ARCHITECTURAL REVIEW COMMITTEE MEMORANDUM

SUBJECT: A REQUEST BY JERRY G. JOHNSON, ON BEHALF OF V.I.P. MOTOR CARS, LTD., FOR A MINOR ARCHITECTURAL (MAA) APPLICATION FOR PARTIAL DEMOLITION, A 1,973-SQUARE-FOOT ADDITION, AND EXTERIOR ALTERATIONS TO AN EXISTING AUTOMOTIVE DEALERSHIP BUILDING, GENESIS PALM SPRINGS, LOCATED AT 4057 EAST PALM CANYON DRIVE (APN: 681-070-034), ZONE C-2, SECTION 30 (CASE 3.1358 MAA). (NK)

PROJECT DESCRIPTION:

DECOMPOSED GRANITE AND ROCK BED, TO MATCH ADJACENT LANDSCAPING AT HYUNDAI. DROUGH TOLERANT PLANTS, DRIP IRRIGATION SYSTEM BY OTHERS.

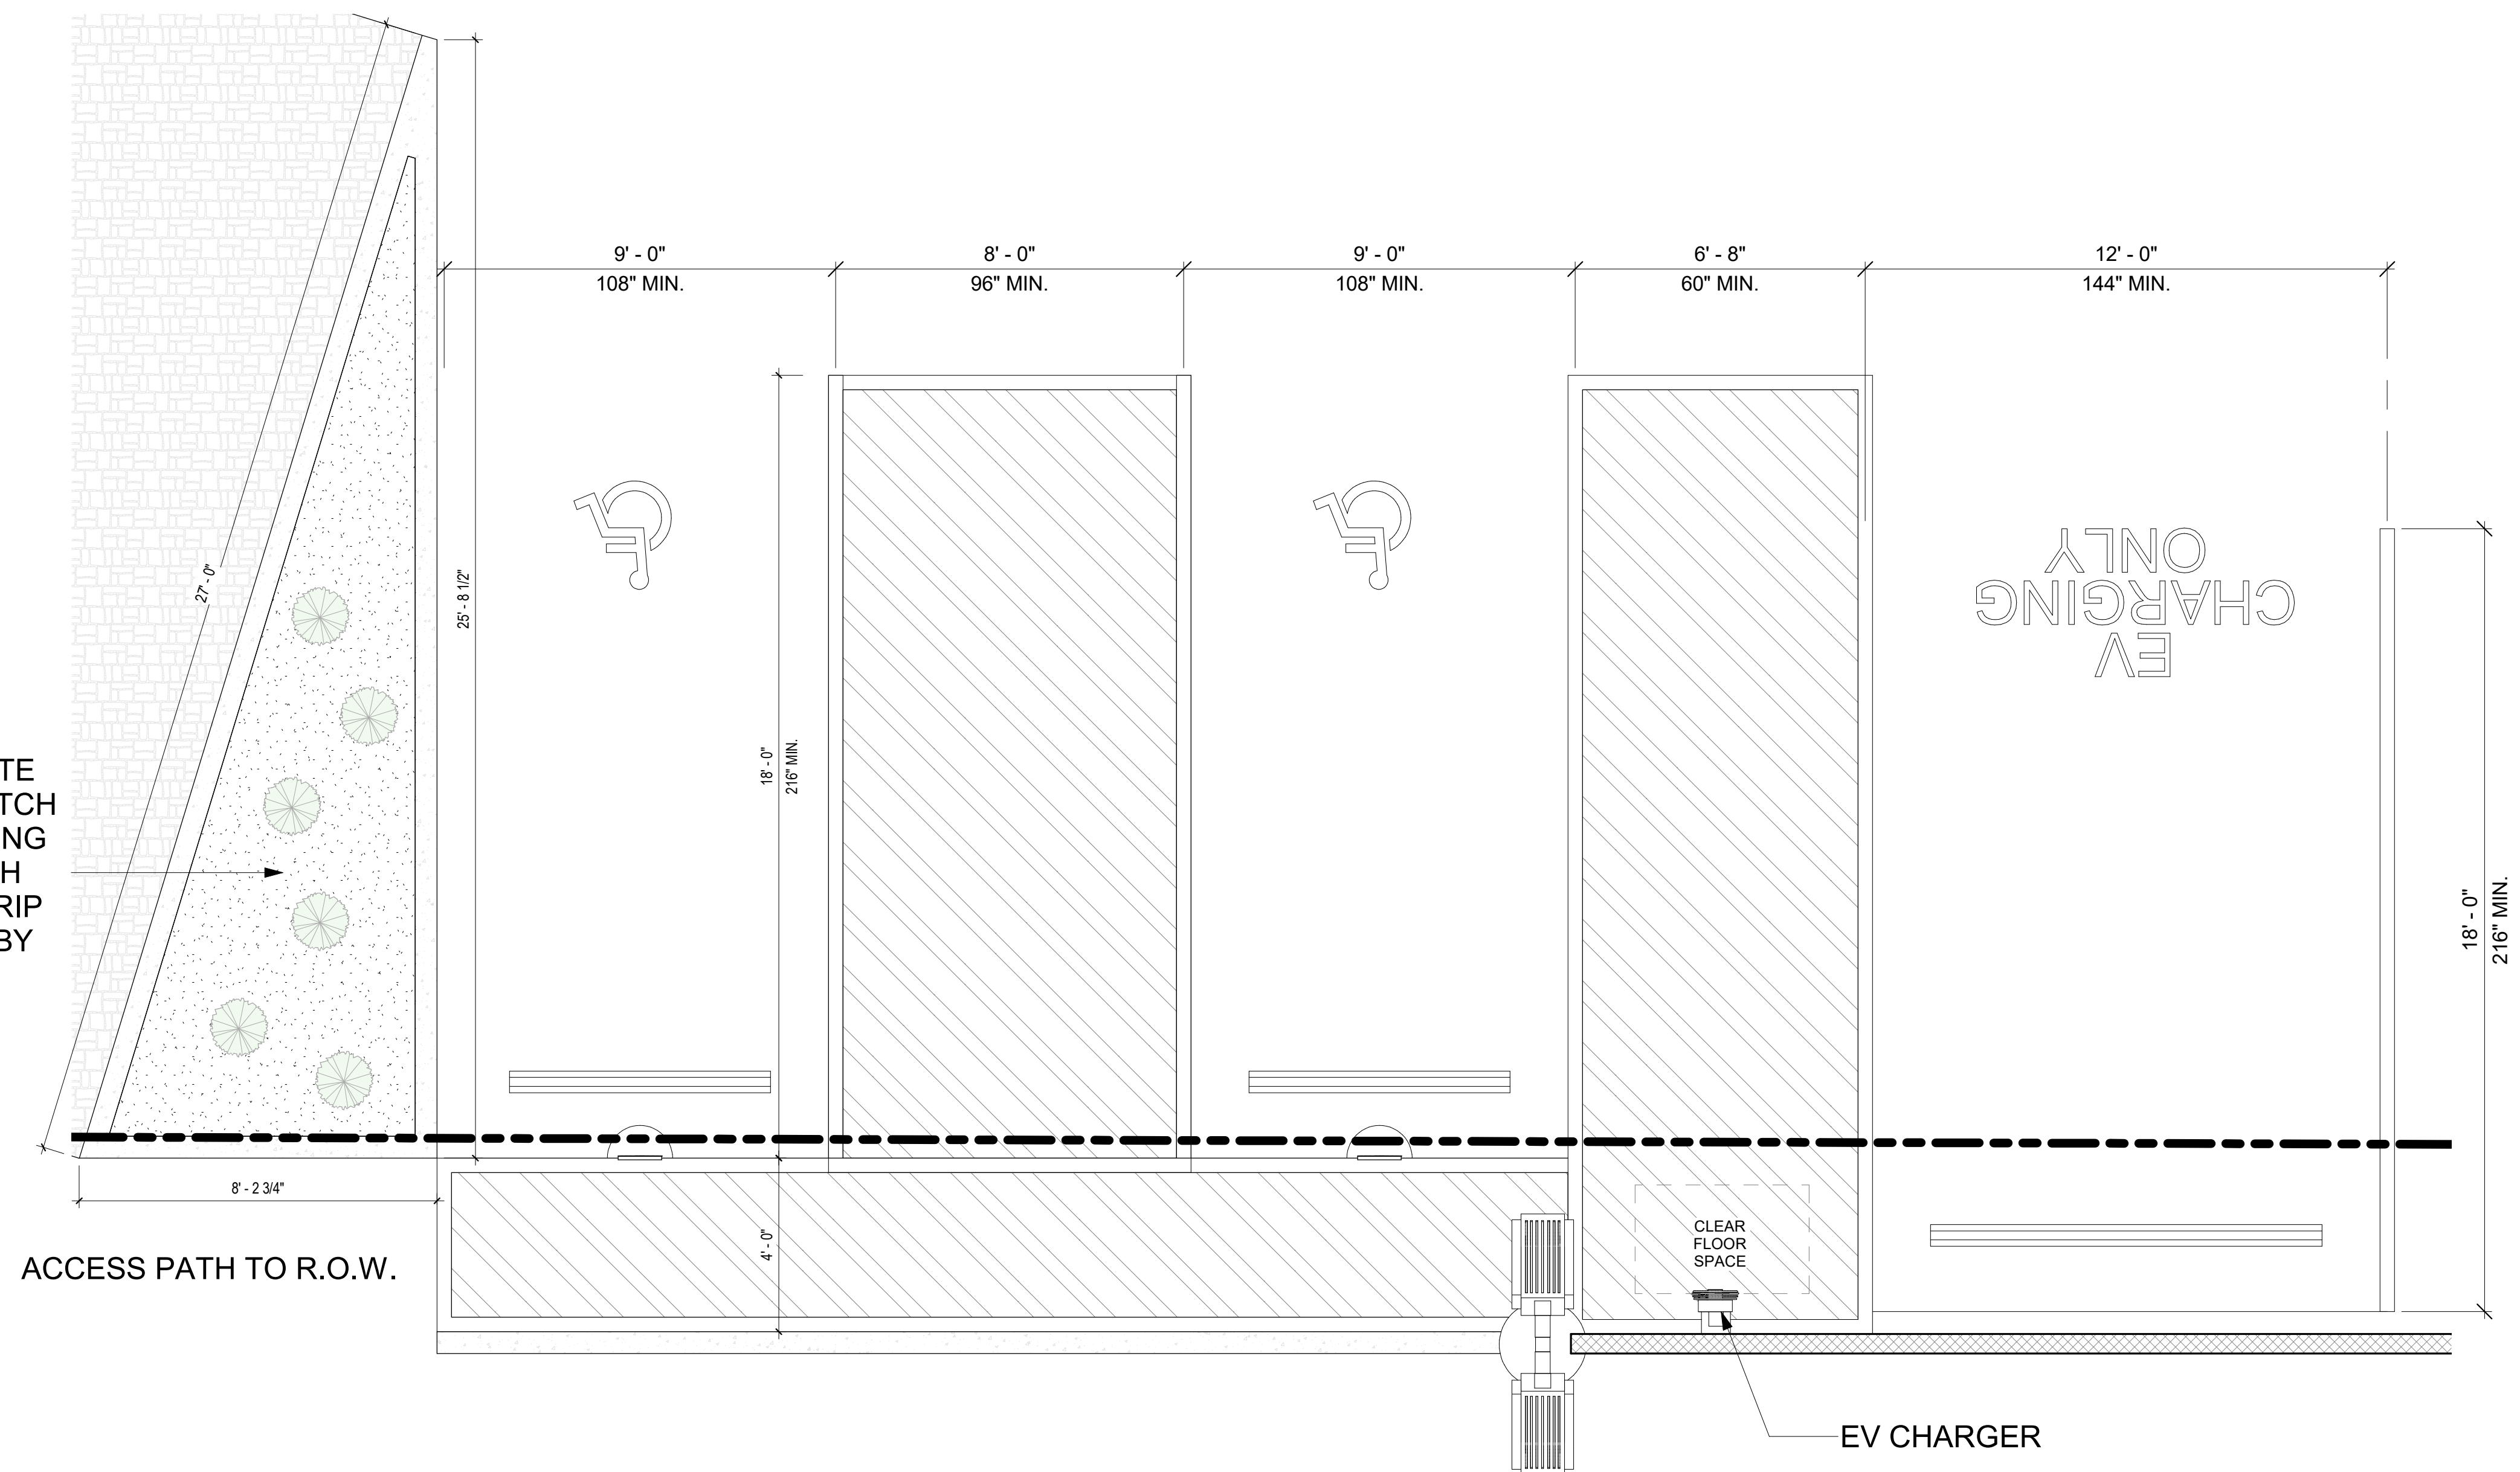
7.	<p><i>The proposed landscape plan is consistent with the requirements of PSMC Chapter 8.60;</i></p> <p>The project proposes the installation of Red Yucca (<i>Hesperaloe parviflora</i>) in the parking areas, which is on the plant list in the Lush and Efficient Landscape Guidelines. No turf is being proposed, and the proposed landscape will be irrigated via drip irrigation. Hence, the proposed landscape plan generally meets the requirements of PSMC Chapter 8.60.</p>	Y

8.	<p><i>The proposed landscape plan is consistent with all applicable zoning requirements, including any streetscape requirements, landscape buffer requirements, and screening requirements;</i></p> <p>Two of the four proposed planting beds are nonconforming to the minimum width requirement of 9 feet. Staff is recommending conditions of approval which require the width of the planting beds to be at least 9 feet for the substandard planting beds. The project proposes the installation of Red Yucca (<i>Hesperaloe parviflora</i>) only. While Red Yucca is on the plant list in the Lush and Efficient Landscape Guidelines, its sparse placement and single-plant landscape plan appear too monotonous and incomplete. In addition to the conditions mentioned earlier, staff is recommending a condition of approval which requires an increase in plant diversity and improved composition in each planting area to better complement the building, as well as the installation of shade trees. As conditioned, the proposed project meets this requirement.</p>	Yes, as conditioned

- PLN 6. Plant Palette. Increase the plant diversity and arrange the plants to achieve sounding composition. Install shade trees in the new parking area planting beds.
